Subject: RE: 9100 Florence NE (B20D024)

This email serves to notify you that the City of Albuquerque, Development and Review Department has reviewed the Amended Grading and Drainage Plan (Engineer's Stamp date 5-19-14) for the Property at 9100 Florence Ave. NE.

Permit: PWDN2014-0036

9100 FLORENCE AVENUE N.E. AMENDED GRADING AND DRAINAGE PLAN

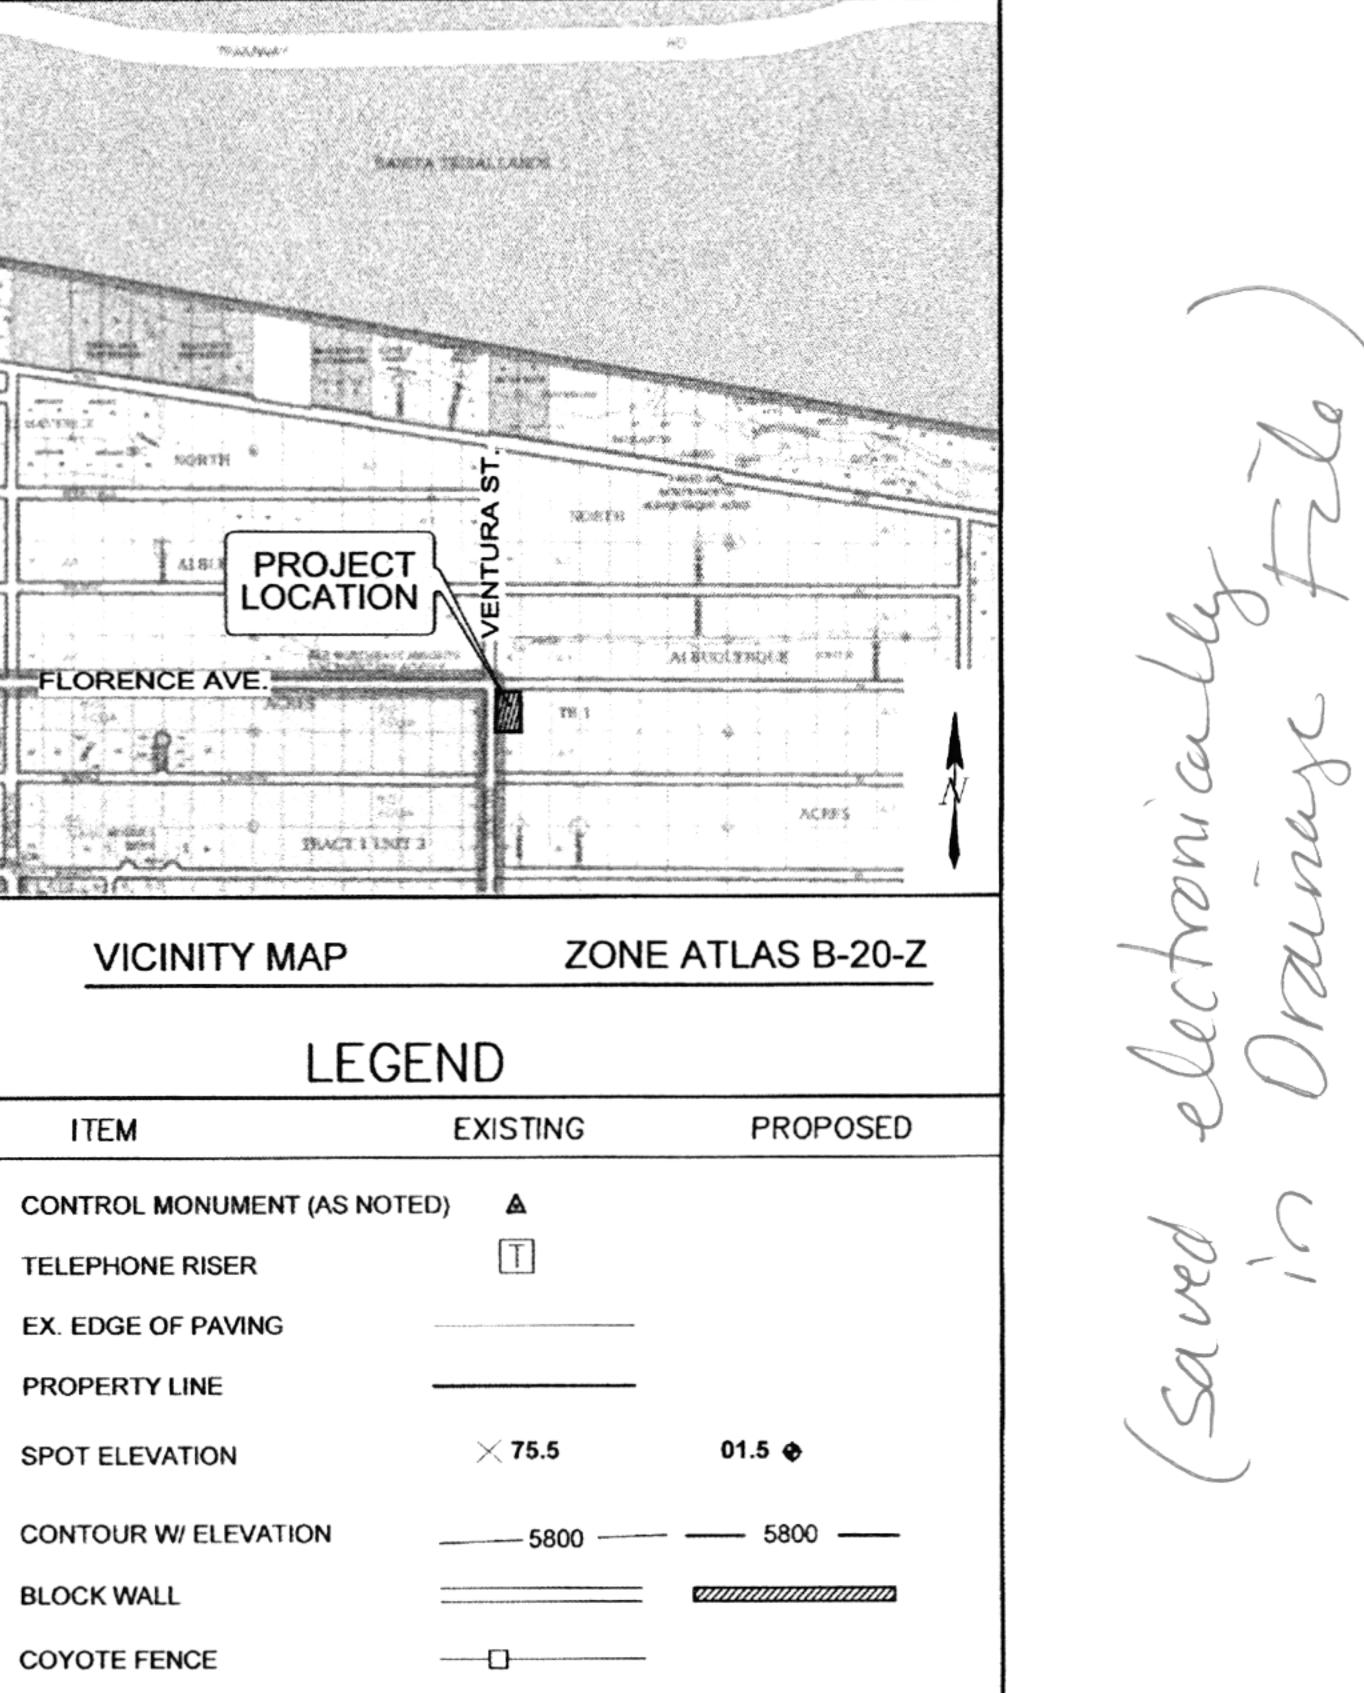
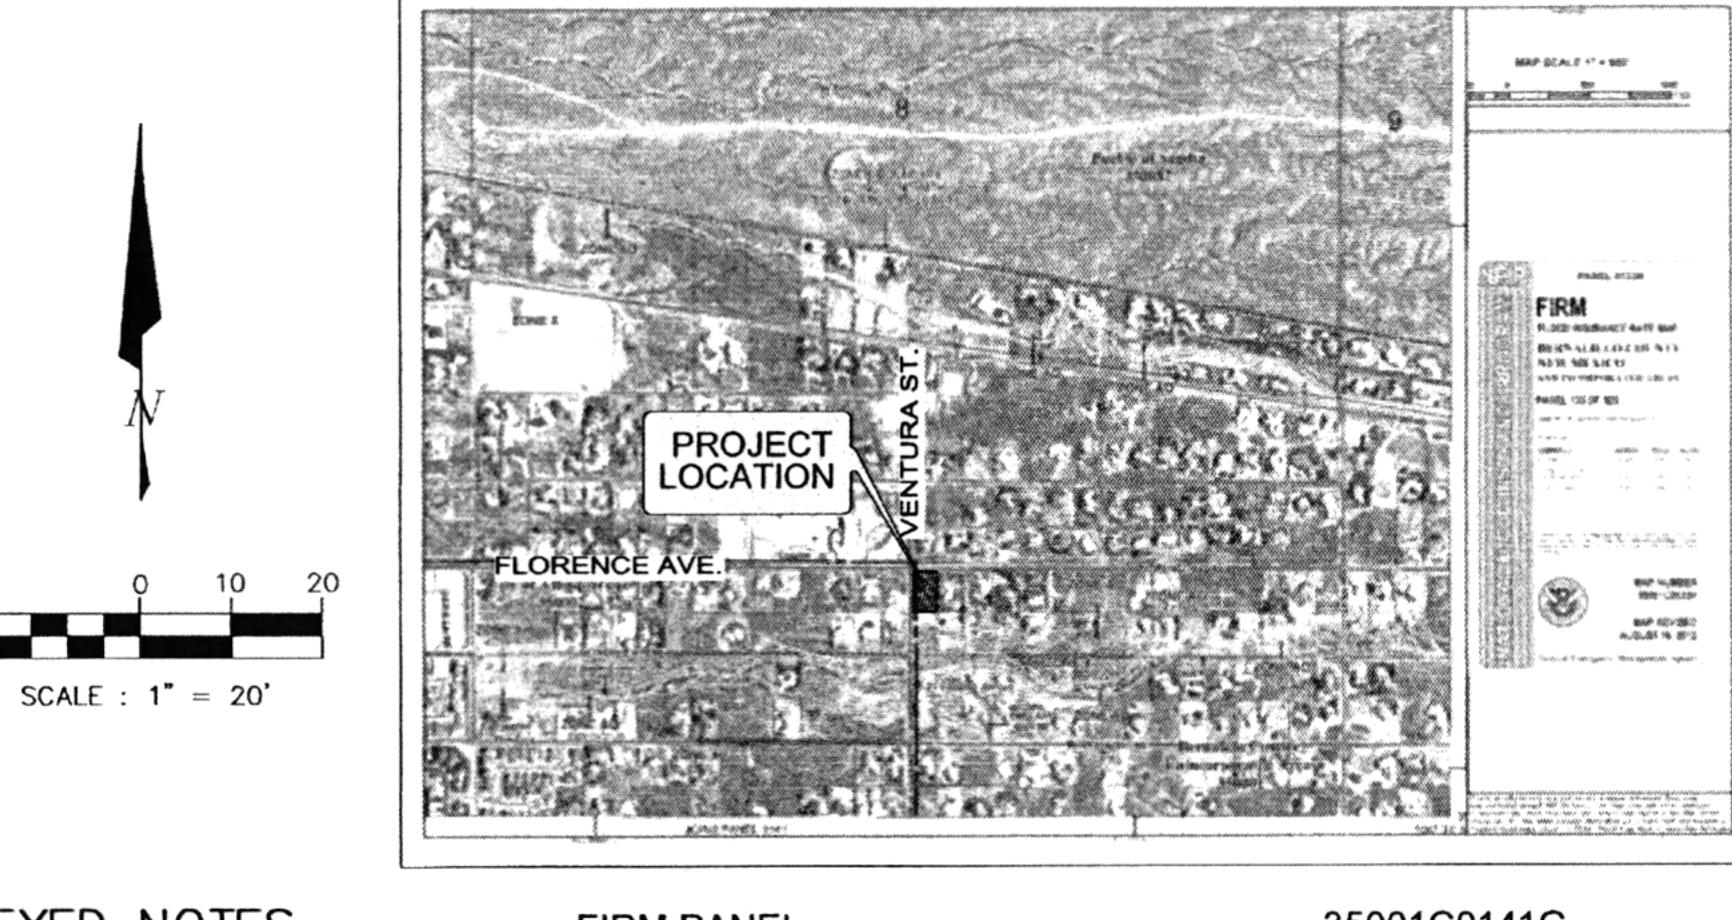
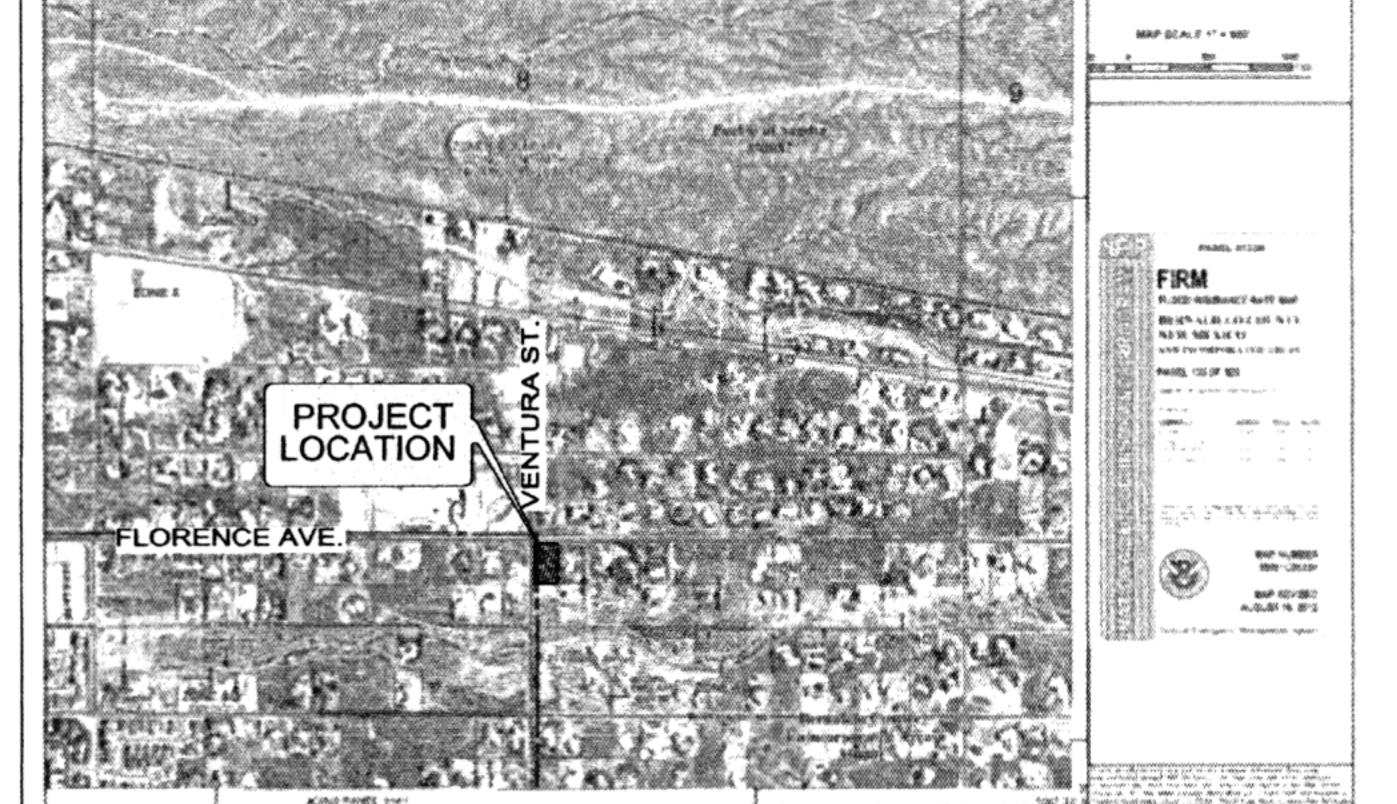
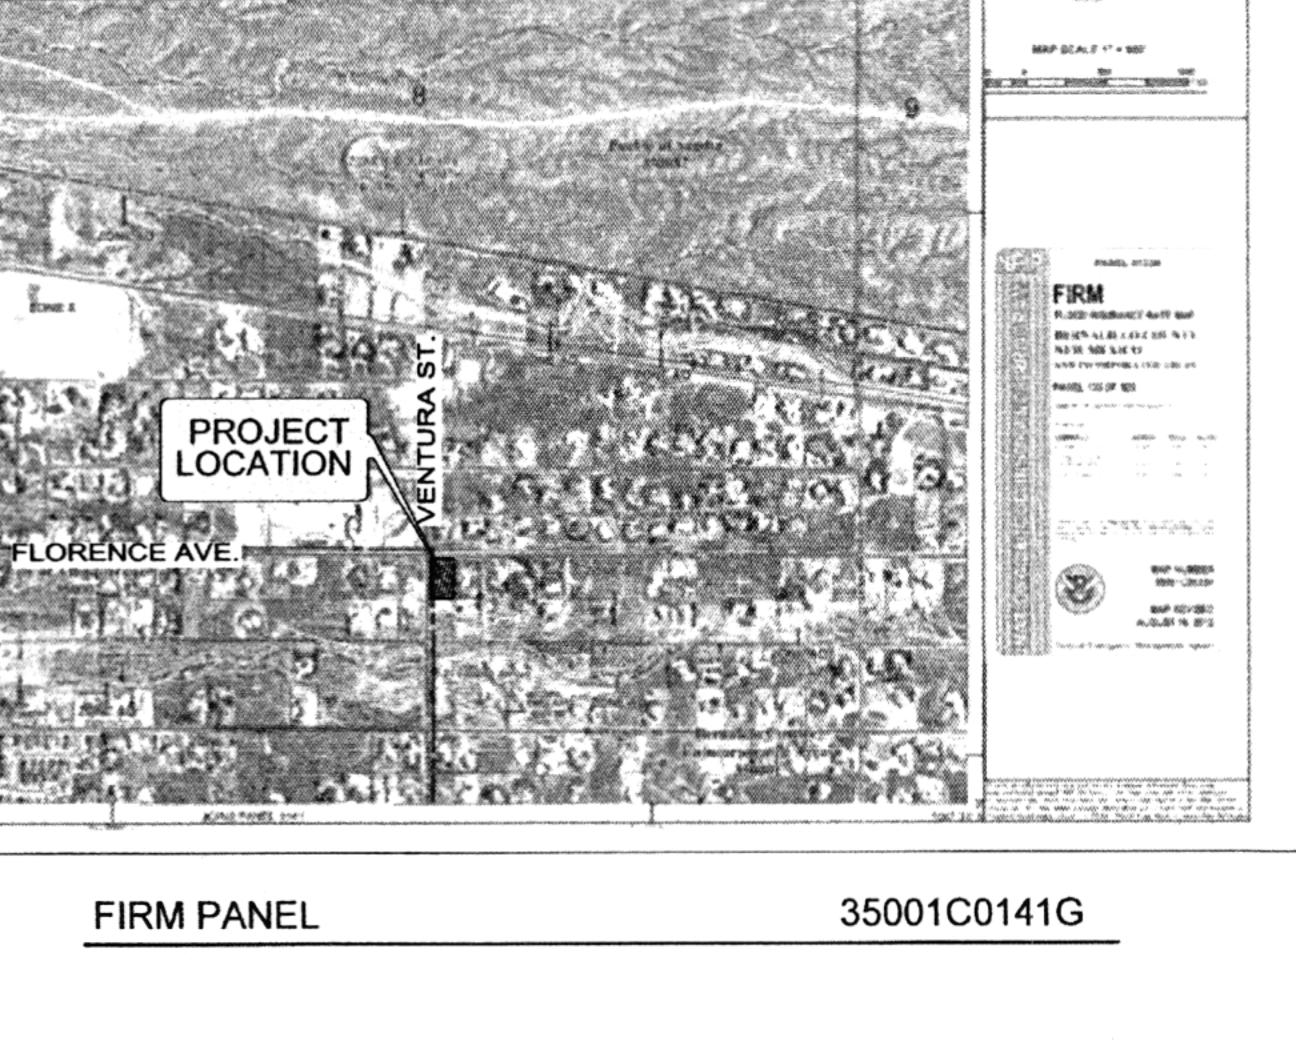
1) Please revise hydrology calculations based on an allowable 43, 20, 20, 17 land treatment balance for the A, B, C, D land treatments respectively.

2) As a protion of the lot drains to the City of Albuquerque right of way. Please provide a letter from the City indicating acceptace of this discharge.

The discharge from the Proposed development is less than the existing conditions discharge. Therefore, the City takes no issue and accepts the proposed discharge from this site.

Attached is the updated Grading and Drainage plan for the subject project. At your request, we have subdivided Basin 'B' in to 2 basins. Basin B-1 drains north to Florence. Basin B-2 drains to the ponding area located in the rear yard. Since Basin B-2 is a closed basin, the proposed peak developed flowrate existing the property into City ROW will be less than the existing condition.
